FIRE SAFETY FOLLOW UP INSPECTION

Factory Name	Arunima Sportswear Ltd		Accord ID	9707
Address	Zirabo, Savar, Dhaka			
Inspection Date	22/04/2014		Report Received Date	
Date of 1st Follow-up	29/10/2015	Date of 2nd Follow-up	13/03/2016	
Date of 3rd Follow-up	21/03/2017	Date of 4th Follow-up	03/07/2017	
Date of 5th Follow-up	09/11/2017	Date of 6th Follow-up	03/06/2018	
Date of 7th Follow-up	13/03/2019	Date of 8th Follow-up		
Date of 9th Follow-up		Date of 10th Follow-up		
Date of 11th Follow-up		Date of 12th Follow-up		
Date of 13th Follow-up		Date of 14th Follow-up		
Inspected by	Mahfuza Khanom

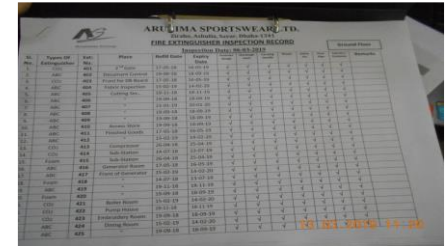
22 Occupant loads are not posted in a conspicuous space near the main exits or exit access doorways as required in Alliance Standard Part 6, Section 6.4.4.

Post the occupant load for every assembly and production floor in a facility in a conspicuous space near the main exit or exit access doorway for the space.

Present Status: In progress. The factory has posted occupants loads in the production floor only near south stair.
 On 21th March 2017 As action plan of the factory: Corrected.
 On 03/07/2017: Corrected.
 On 09/11/2017: Corrected
 On 03/June/2018: Posted
 On 13/03/2019: Corrected.
